**CITY OF HARTFORD CITY  
BLACKFORD COUNTY, INDIANA  
PHASE 4 CSO MITIGATION PROJECT  
MAY 2026**

**Addendum No. 1**  
May 14, 2026

DRAWN DESIGNED CHECKED  
 AR EGC SMS  
 SCALE: AS NOTED  
 SHEET: 32 of 44  
 DATE: 5/14/2026  
 PROJECT NO.: 25-903-01

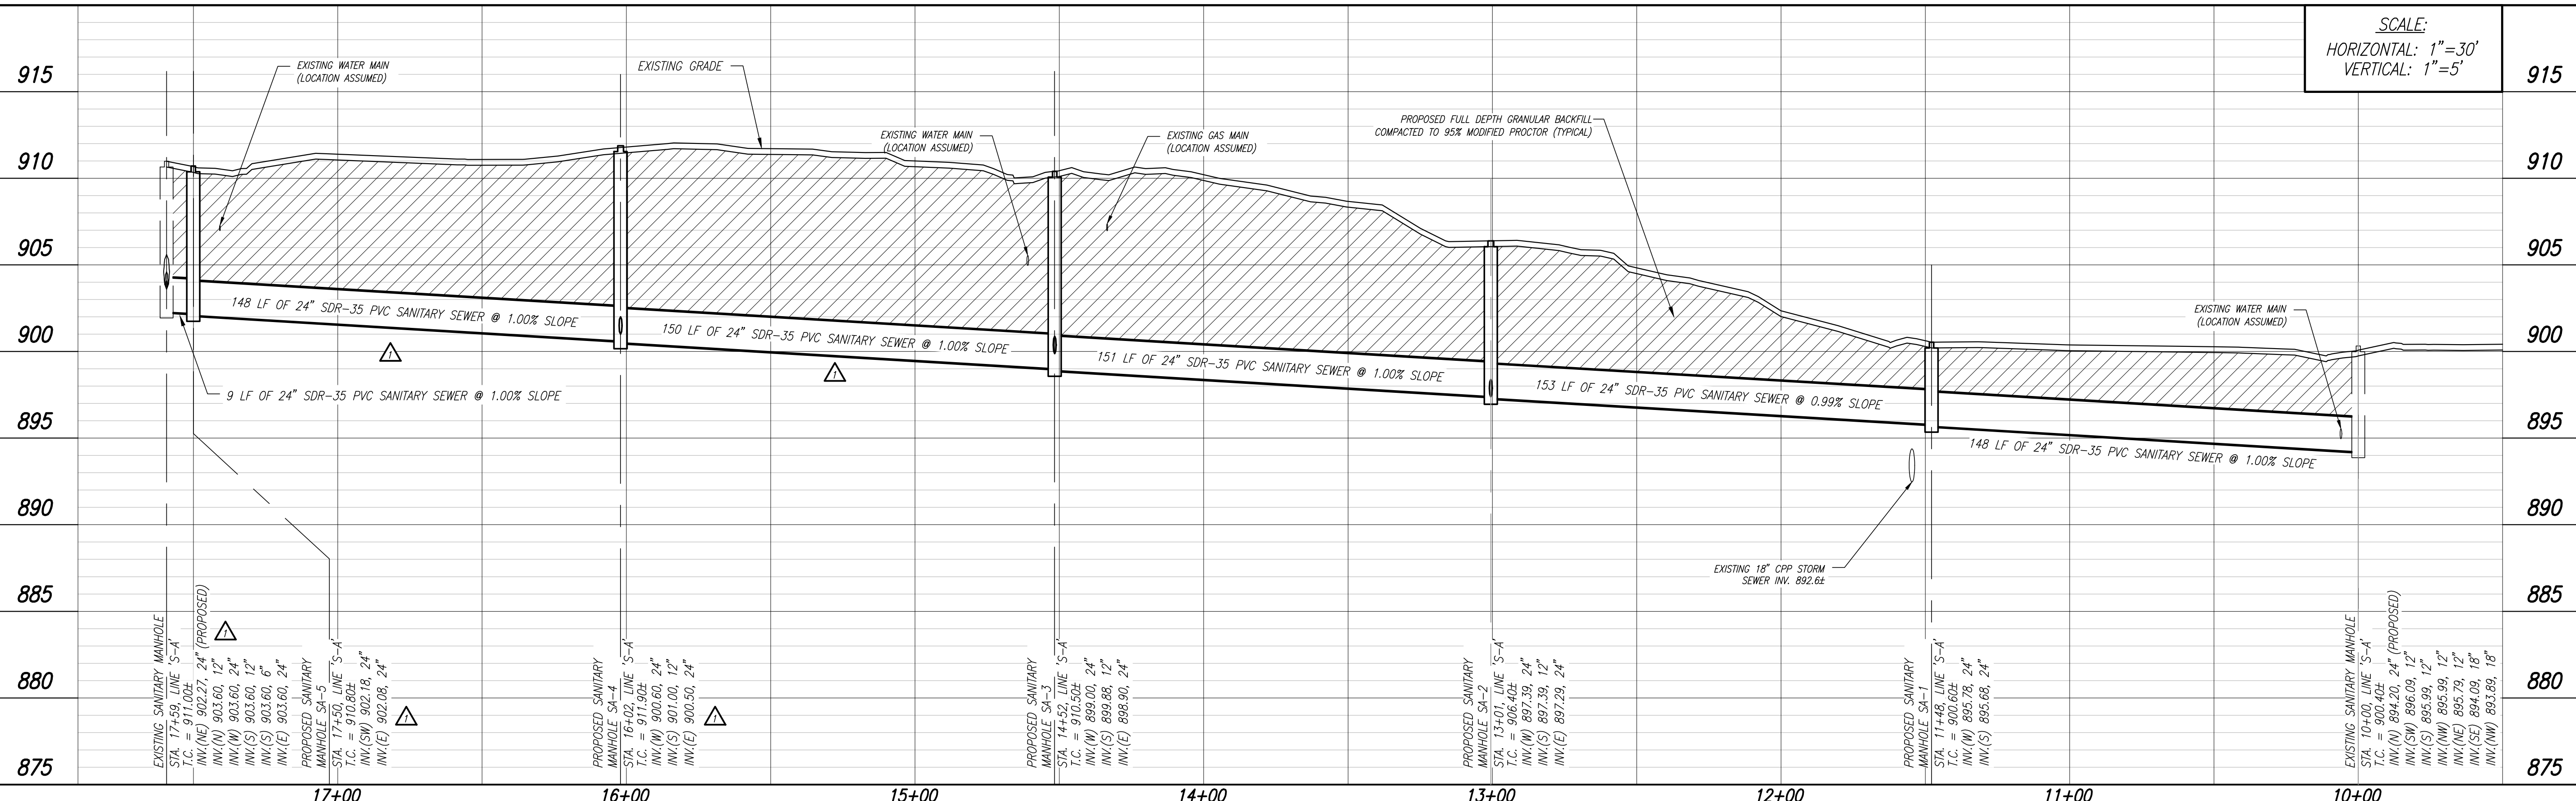
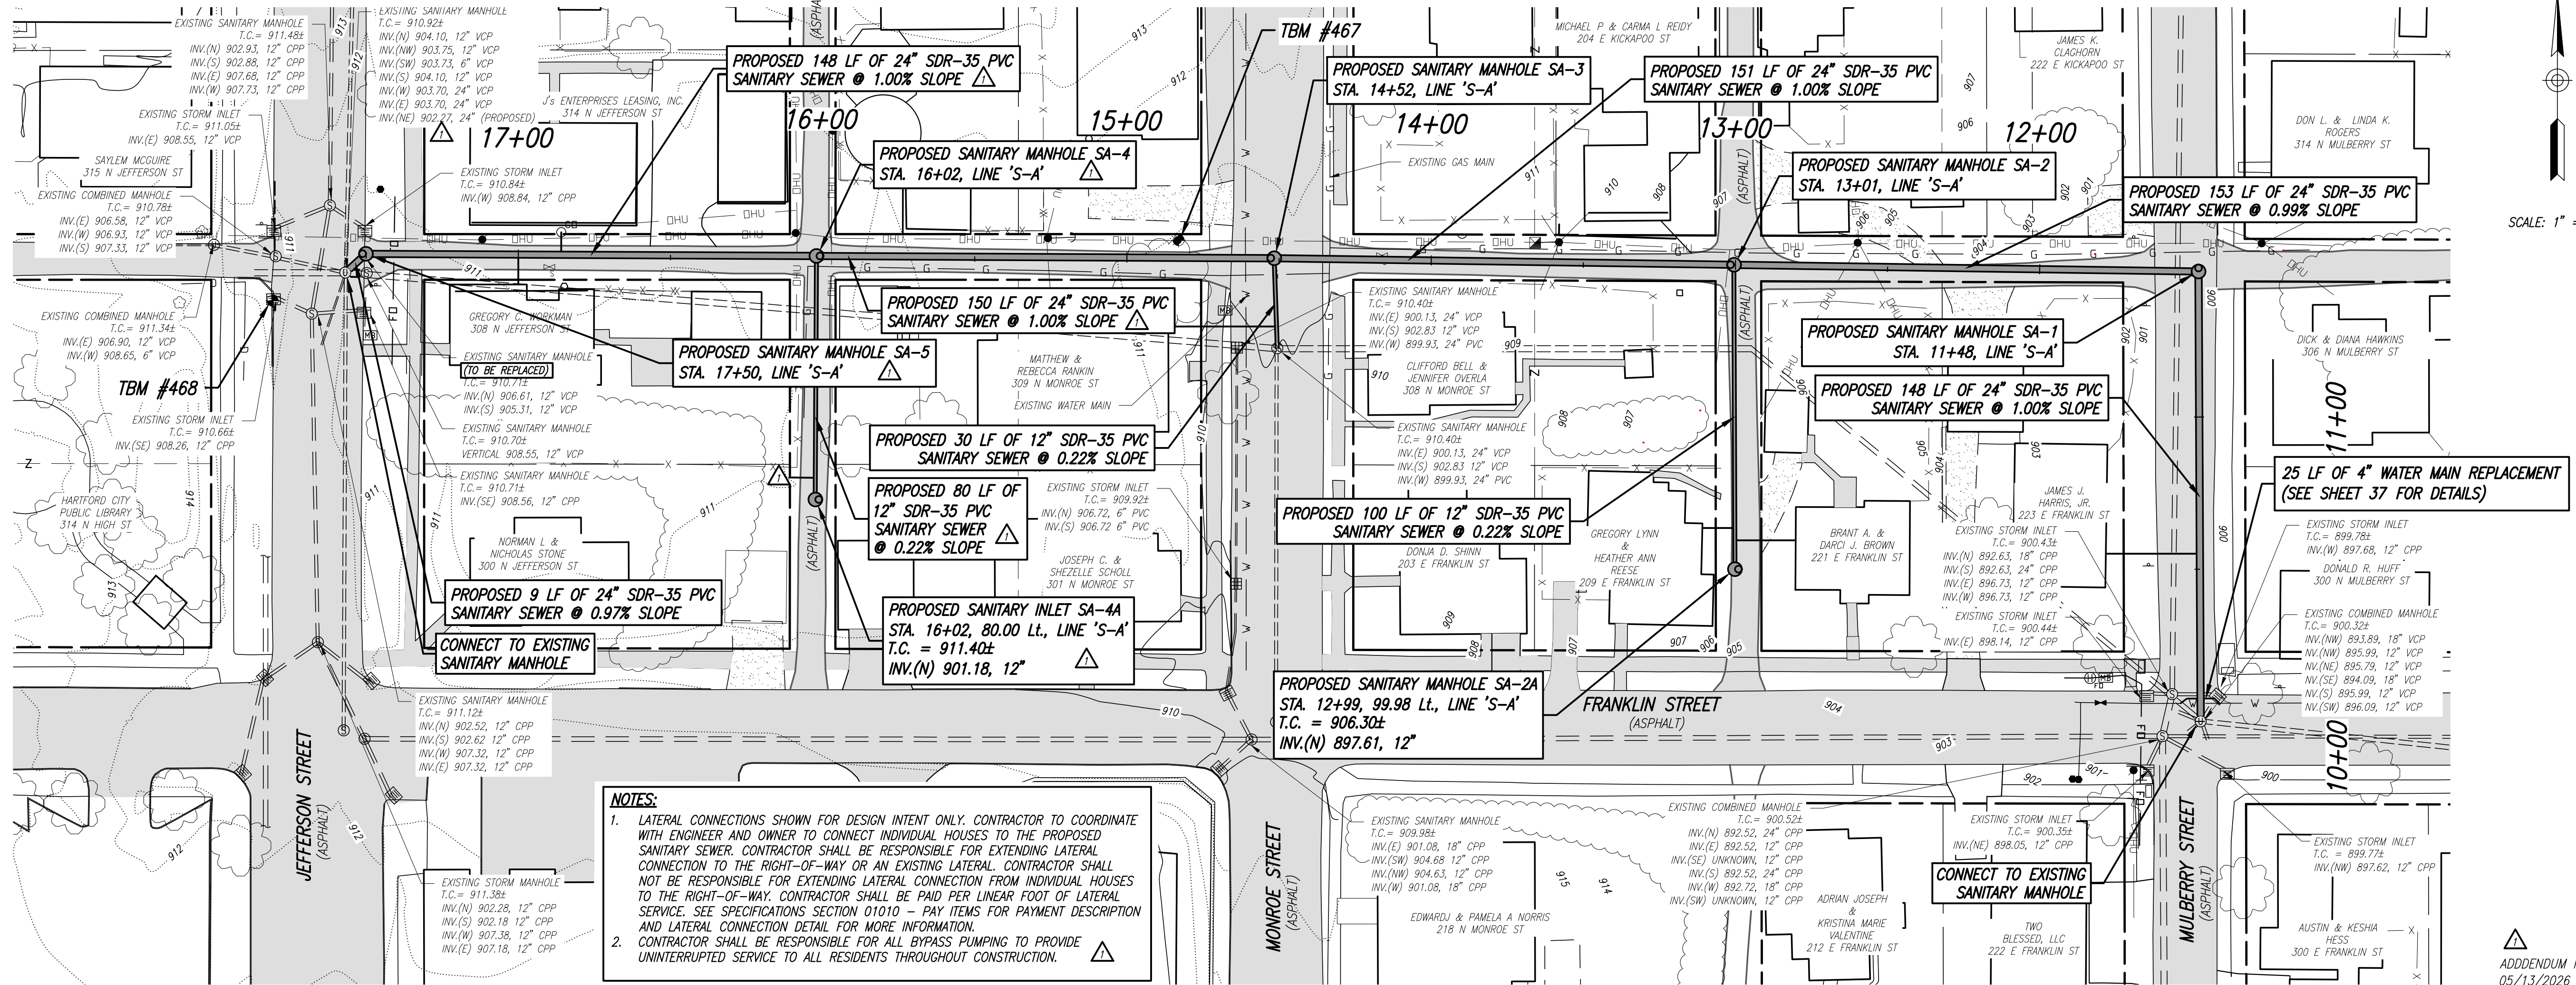
**Item No. 4: Clarification** – Plan Sheet No. 32 – The existing 24-inch sanitary sewer shall be completely filled with flowable fill. Flowable fill shall be in accordance with Specification Section 03100. Contractor shall anticipate additional excavation and restoration areas to ensure complete abandonment and fill of existing pipe.

**Item No. 5: Revision** – Revised Plan Sheet No. 32 – A 48-inch standard sanitary manhole shall be added at station 16+02 and a sanitary sewer extension shall extend south in the alley between Jefferson Street and Monroe Street to collect flow from 300 N Jefferson Street. The revised plan sheet contains all additions and revisions.
